CITY PLAN COMMISSION**THURSDAY, MAY 7, 2026****FILE NUMBER:** PLAT-26-000093**SENIOR PLANNER:** Sharmila Shrestha**LOCATION:** Hull Avenue, south of Linfield Road**DATE FILED:** April 10, 2026**ZONING:** R-5(A)**CITY COUNCIL DISTRICT:** 7**SIZE OF REQUEST:** 0.5308-acres**APPLICANT/OWNER:** AAAA Plus Surveyors, LLC

REQUEST: An application to replat a 0.5308-acre (23,123-square foot) tract of land containing part of Lot 1 in City Block 7638 to create three 0.1769-acre (7,708-square foot) lots on property located on Hull Avenue, south of Linfield Road.

EXISTING AREA ANALYSIS MAP

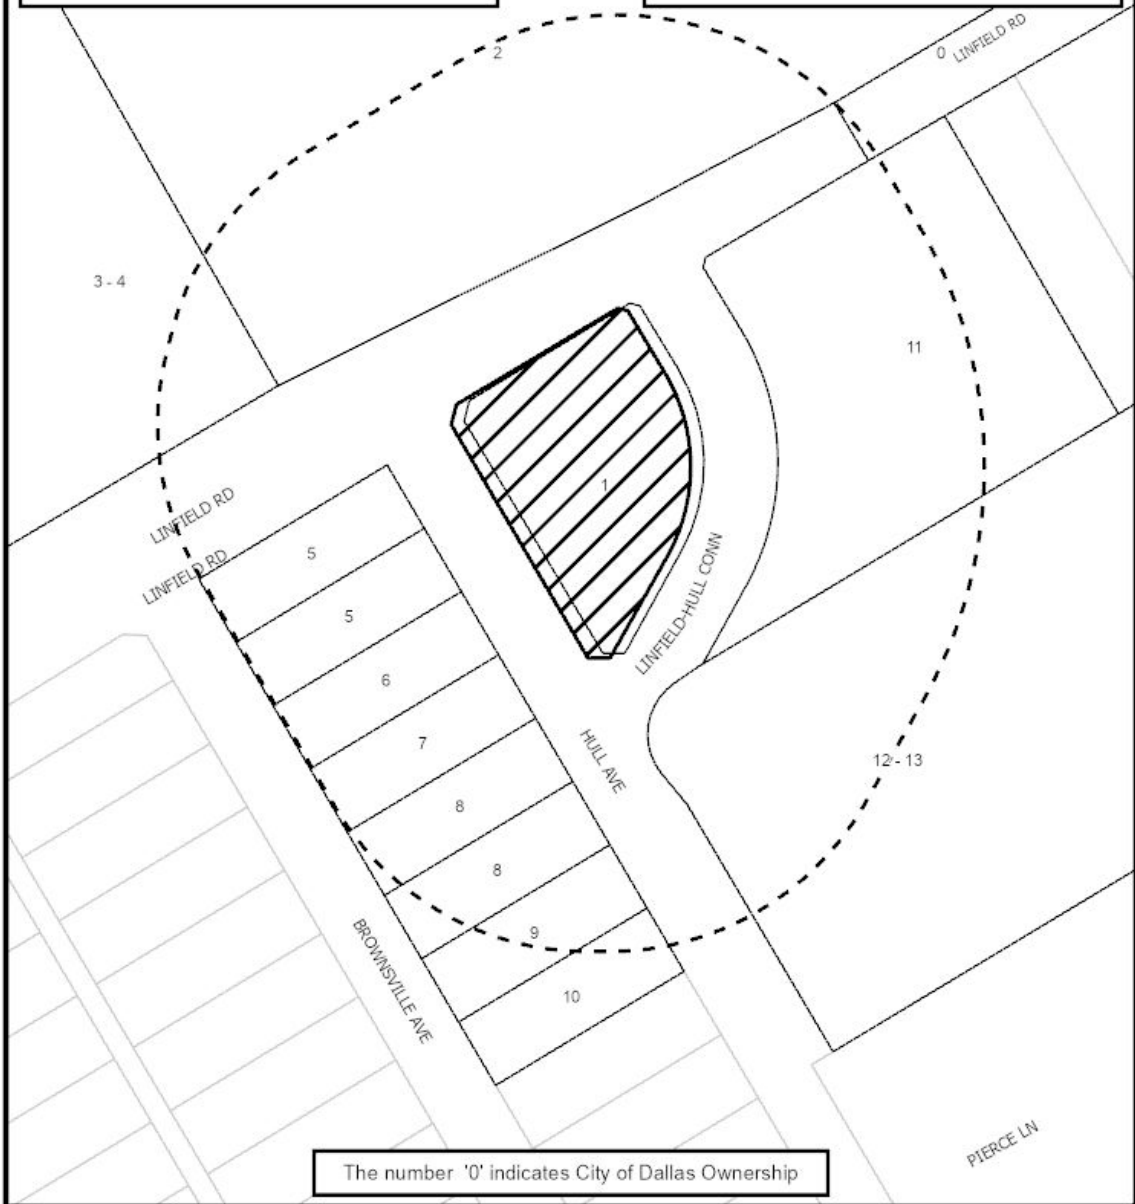
Staff find that there is not an established lot pattern within the immediate vicinity of the request (refer to the existing area analysis map and aerial map) and the request complies with the requirements of Section 51A-8.503 and R-5(A) Single Family District; therefore, staff recommend approval of the request subject to compliance with the following conditions:
